Access Compliance Report Public Rights-of-Way (Curb Ramps)

Main Street: MARTHA_ANN_DR Cross Street: BOSTONIAN_DR Location: E

ADA ID: RPRK211220130724 Ramp Type: Type 4 - Parallel Initial Pass/Fail: Fail Overall Compliance: No Severity Score: 2

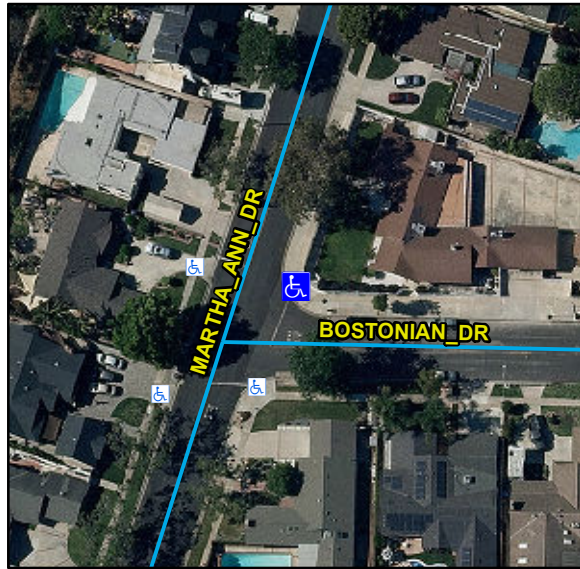
Compliance	Description	Data	Compliance	Description	Data
N/A	Ramp Length LT (in)	119	N/A	Ramp Length RT (in)	111
Yes	Ramp Width LT (in)	124	Yes	Ramp Width RT (in)	124
Yes	Ramp Run Slope LT (%)	5.3	Yes	Ramp Run Slope RT (%)	4.7
No	Ramp Cross Slope LT (%)	3.4	Yes	Ramp Cross Slope RT (%)	2
N/A	Landing Present	N/A	N/A	DWS Provided	N/A
N/A	Landing Length (in)	N/A	N/A	DWS Contrast	N/A
N/A	Landing Width (in)	N/A	N/A	DWS Length (in)	N/A
N/A	Landing Run Slope (%)	N/A	N/A	DWS Full Width	N/A
N/A	Landing Cross Slope (%)	N/A		DWS Offset Type	N/A
N/A	Landing Movement Obstructed?	N/A	N/A	DWS Offset Left (in)	N/A
	Landing Movement Type	N/A	N/A	DWS Offset Right (in)	N/A
N/A	Landing Shared	N/A			
N/A	Clear Space	Yes			
N/A	Clear Space To Crosswalk (in)	N/A			
N/A	Marked Crosswalk 1	No	N/A	Marked Crosswalk 2	No
	Crossing 1 Direction	NW		Crossing 2 Direction	SW
	Marked Crosswalk 1 Width (in)	N/A		Marked Crosswalk 2 Width (in)	N/A

Remove & Replace Curb Ramp With Two New Directional Ramps or Equivalent.
